**GOVERNMENT OF INDIA
NORTH EASTERN COUNCIL SECRETARIAT
NONGRIM HILLS, SHILLONG – 793003**

Subject: Forwarding of Inspection Report.

Report of the inspection carried on 09 / 02/2018 for the NEC funded project "Construction/Remodelling of RCC building including Development of Library,Vocational Centre etc.of Madhav Dev Higher Secondary School at Tulsimukh,Nagaon"

View of Boundary Wall at Madhav Dev Higher Secondary School in Tulsimukh

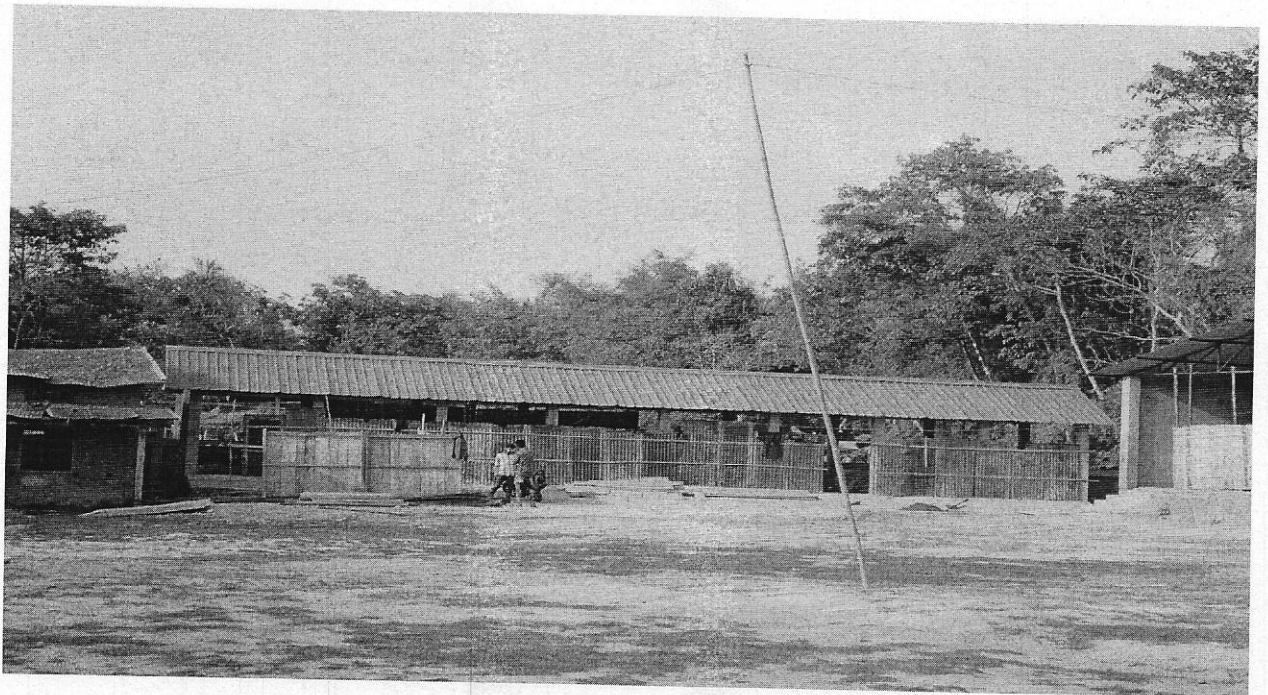
3.	Construction of boundary wall	2586050.00	During inspection it was found that total 261.65 m boundary wall constructed in the school compound. As per approved DPR total 265 m boundary wall was proposed. It could be seen that finishing work at the top portion of the pillar of the boundary wall, installing MS Grill above the brick wall, painting works not yet completed.

View of Cycle Stand at Madhav Dev Higher Secondary School in Tulsimukh

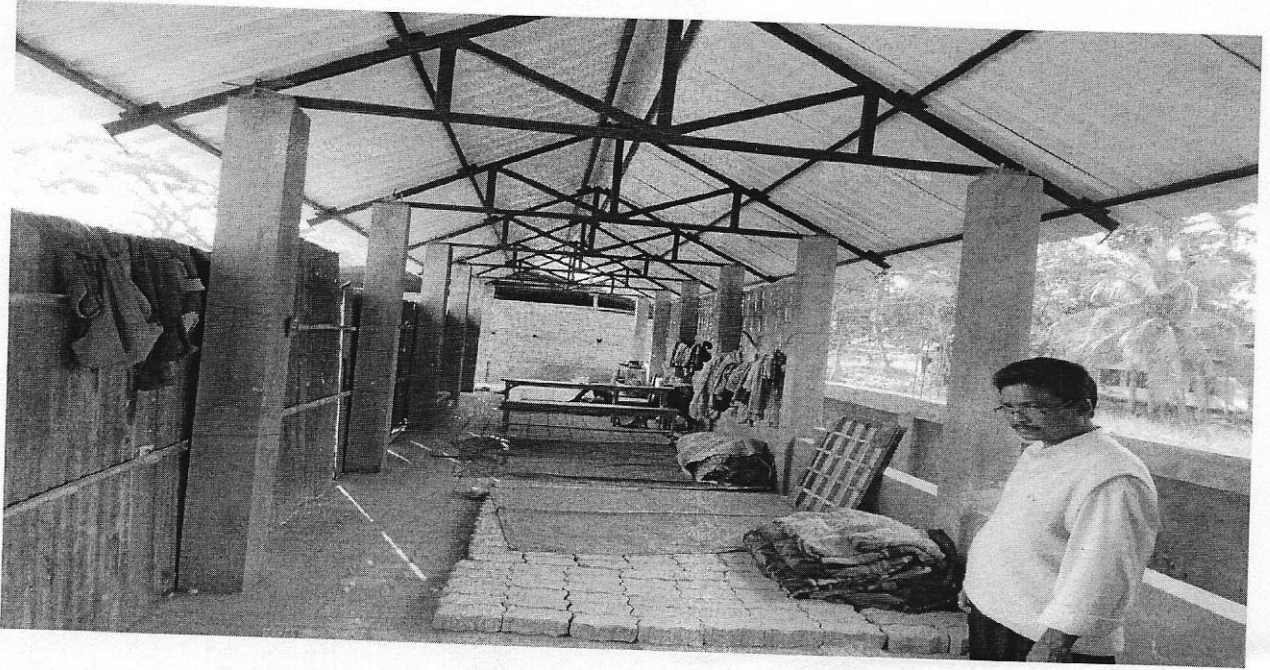
2.	Construction of Cycle Stand	642518.00	Construction of Cycle Stand already completed except painting works of truss and building portion and putting checkered tiles in the ramp section. It was found that Cycle Stand had been constructed as per approved DPR dimensions.

View of Toilet Block at Madhav Dev Higher Secondary School

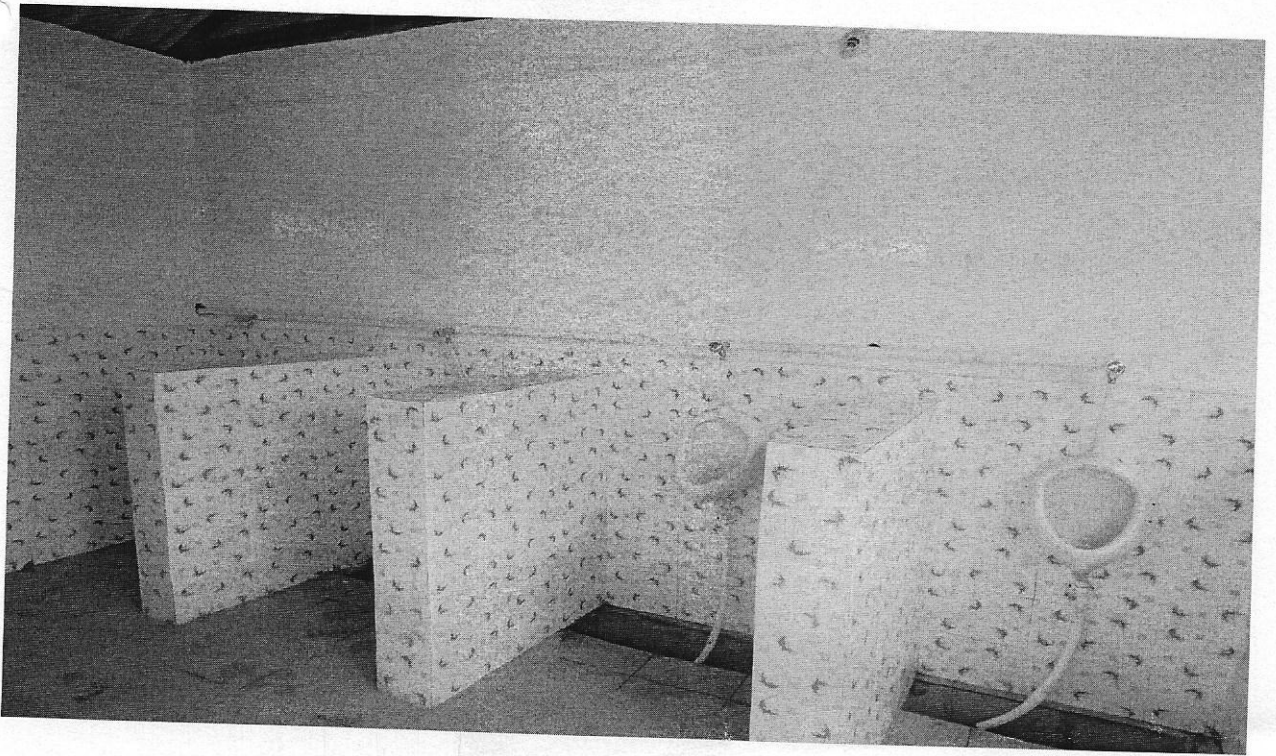
6.	Construction of outside toilet block	1017483.00	Construction of toilet block completed except painting works of truss and construction of two more wash basin. Total Plinth area of 38.13 sqm. was proposed in

the approved DPR., but 35.874 sqm. toilet block was found constructed.
7.	Repairing /Maintenance of existing Assam type building	257282.00	Not yet done.
